**TITEL:** Korrosionskontroll av vingstöttor

**BESLUTSDATUM:** 1998-10-20

**LFS 1998:68**

**98-15-18 MAULE AEROSPACE TECHNOLOGY CORP.:** Amendment 39-10669; Docket No. 98-CE-01-AD; Supersedes AD 95-26-18, Amendment 39-9476.

Figure 1

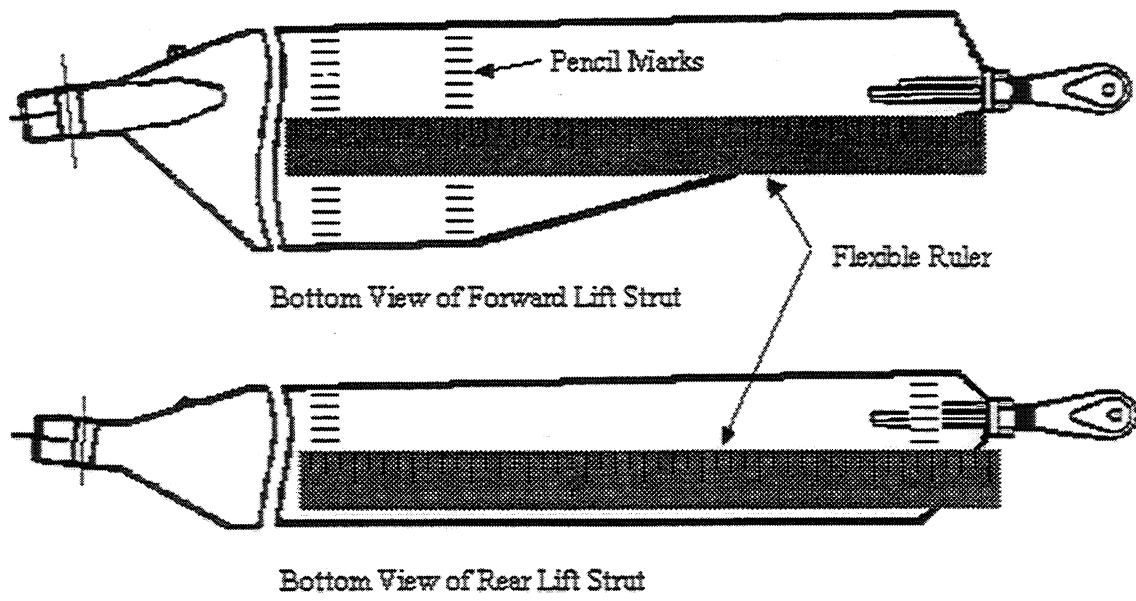
2. Using a flexible ruler, draw a 1/4-inch grid on the surface of the first 11 inches from the lower end of the strut as shown in Maule Service Bulletin No. 11, dated October 30, 1995, as applicable. This can be done using a soft (#2) pencil and should be done on both faces of the strut. As an alternative to drawing a complete grid, make two rows of marks spaced every 1/4 inch across the width of the strut. One row of marks should be about 11 inches from the lower end of the strut, and the second row should be several inches away where the strut starts to narrow. Lay the flexible ruler between respective tick marks of the two rows and use tape or a rubber band to keep the ruler in place. See Figure 1.
